Pentium® Processor Specification Update

Release Date: November 12, 1997

Order Number 242480-032

2. **Incorrect TCP Pinout Drawing**

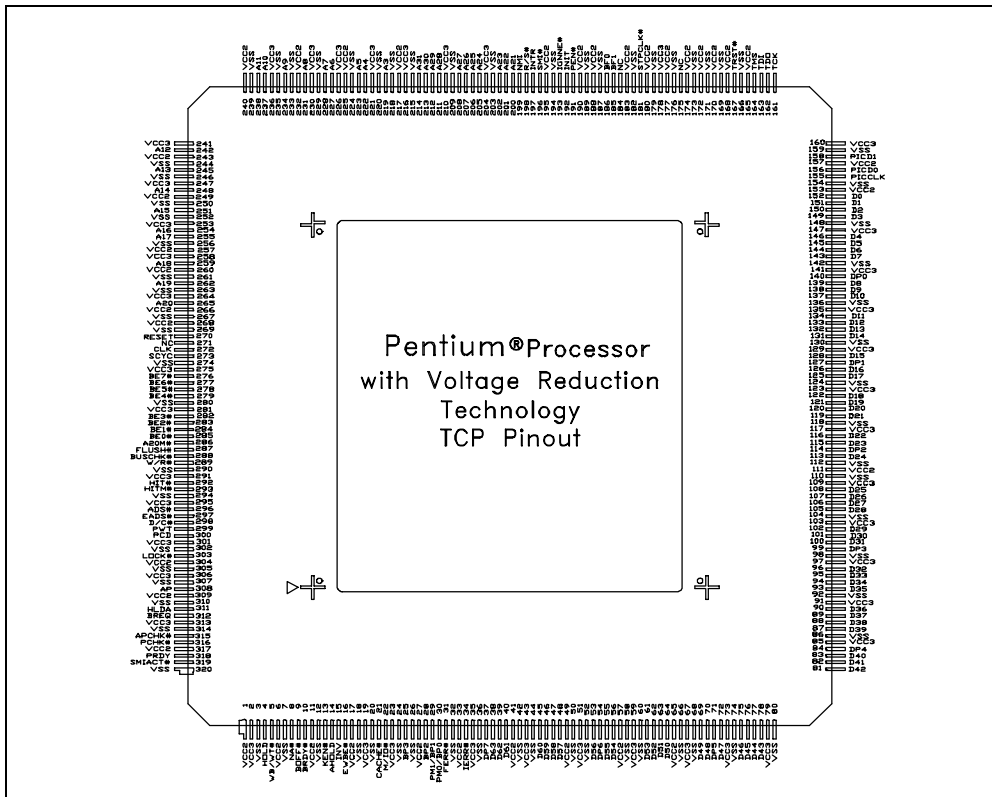
The TCP pinout drawing on page 8 of the *Pentium Processor with Voltage Reduction Technology* datasheet was inadvertently rotated. The correct orientation is shown below.

Figure14-1. Maximum Undershoot Level, Undershoot Threshold Level, and Undershoot Threshold Duration

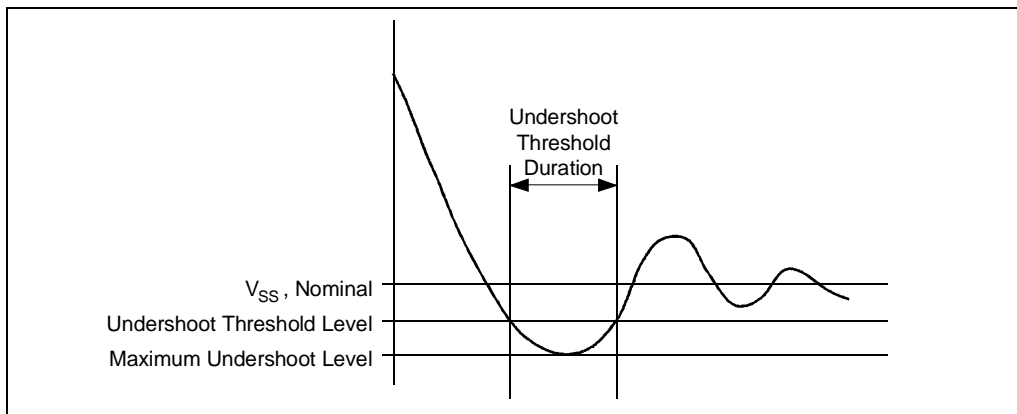
MAXIMUM RINGBACK SPECIFICATION: The maximum ringback of CLK associated with its low state (undershoot) must not exceed 0.8V as shown in Figure 14-1.

UNDERSHOOT THRESHOLD DURATION SPECIFICATION: A snapshot of the clock signal should be taken at 500 mV/div and 500 pS/div (for CLK). Adjust the vertical position and horizontal offset position to view the threshold duration. The undershoot threshold duration is defined as the sum of all time during which the clock signal is below -0.5V within a single clock period. The undershoot threshold duration must not exceed 20% of the period.

This undershoot specifications are illustrated graphically in Figure 14-1 and Figure 14-2.
